Comunicazione tecnica n° **09/09**
Technical communication n: **09/09**

Riferimento modello/i: **Krystal, Fast, Faster**
Machine kind: **Krystal, Fast, Faster**

Oggetto: nuova scheda Power Chain per il modelli sopra citati
Subject: new Chain Power board for the up-written models

Scheda/Board 082636
Stampato/Printed circuit 080636C

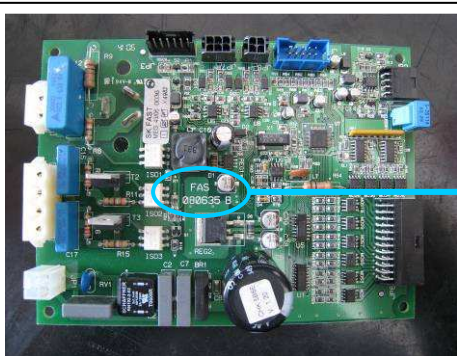
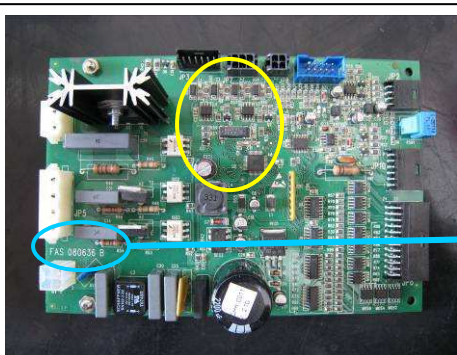
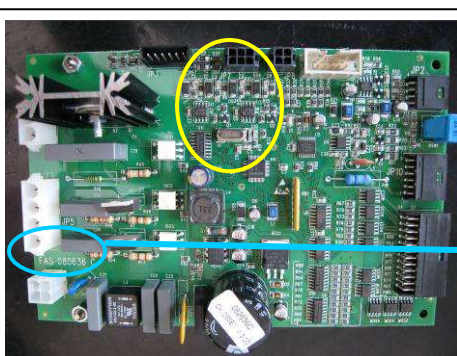
Please be informed, for the up-written models, have been introduced a new Power board code 082636 (printed circuit C). This board replace codes of 082635 and 082636 (printed circuit B).

The new board 082636 (printed circuit 080636C) is compatible with an machines having the previous boards.

Note: the first official release of the new board is V.3.00 cks C65E

Note: la zona evidenziata in giallo indica la parte modificata
The yellow indicated zone is the modified area

Note: la zona evidenziata in giallo indica la parte modificata
The yellow indicated zone is the modified area
